Long Branch Sector Plan, Worksession 2

Description

Exhibit 1: MTA's Proposed Access to Long Branch Recreation Center and Pool (From Eastbound Direction)

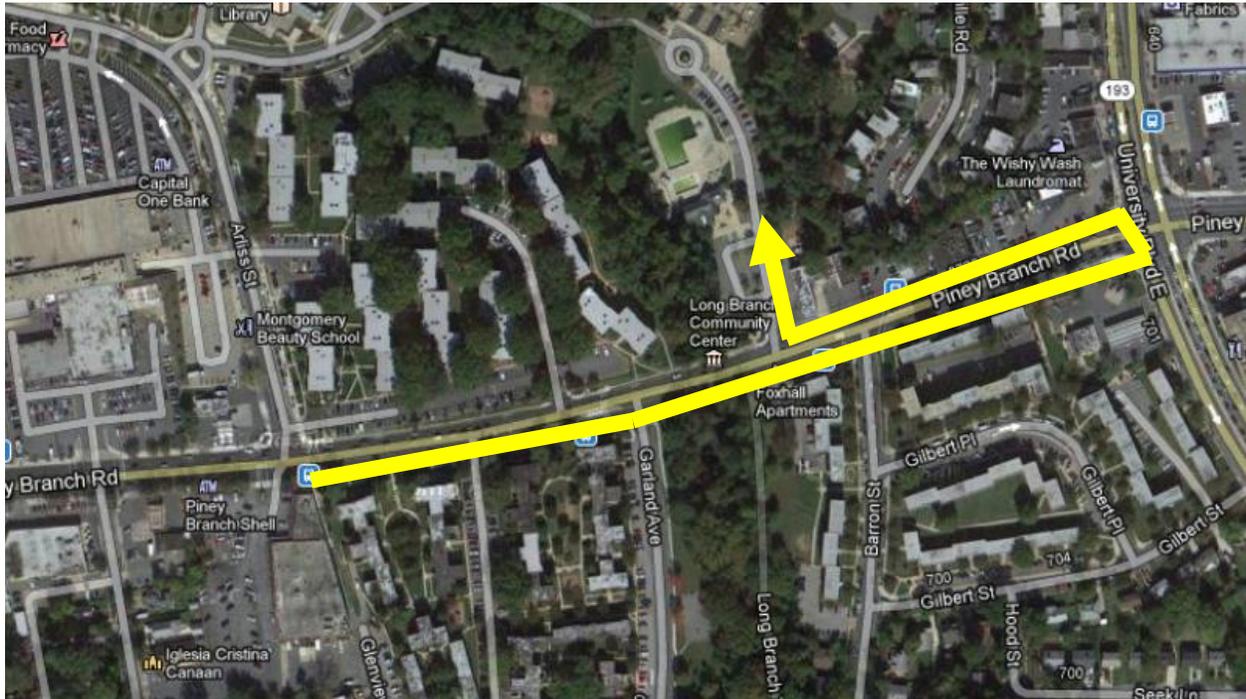
MTA states that facility patrons will still be able to access the facilities via U-turns at Arliss Street and University. Vehicles traveling in the eastbound direction on Piney Branch Road would have to pass the recreation center, make a U-turn at University Blvd., and then turn right into the recreation center (see Exhibit 1).

Exhibit 2: MTA's Proposed Egress from Long Branch Recreation Center and Pool (To Eastbound Direction)

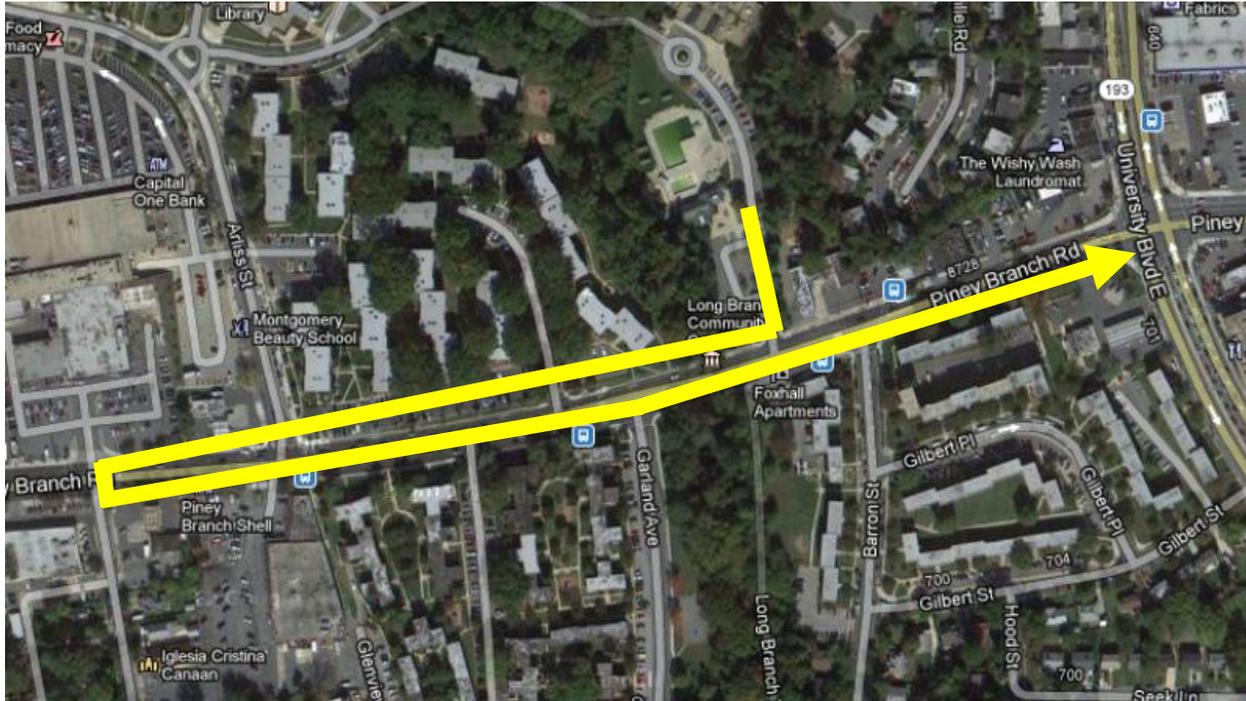
Exiting vehicles headed in the eastbound direction would have to make a right onto Piney Branch Road, make a U-turn at Greenwood Avenue, and then head in the eastbound direction on Piney Branch Road (see Exhibit 2). Of the two access restrictions, the proposed replacement of the entering left turn with a U-turn at University Blvd. is the most concerning.

M-NCPPC staff (Planning Department and Department of Parks) share the concern that these intersections will be complicated enough post-Purple Line and post-Sector Plan implementation and we should not make the intersections even more complicated by encouraging U-turn movements. In addition, the U-turn concept at the intersection of Piney Branch Road and University Blvd. is incompatible with the proposed congestion relief strategy proposed in the Long Branch Sector Plan. This strategy is intended to relocate left turns from eastbound Piney Branch Road to northbound University Blvd. to Gilbert Street Extended proposed at the southwest corner of the intersection.
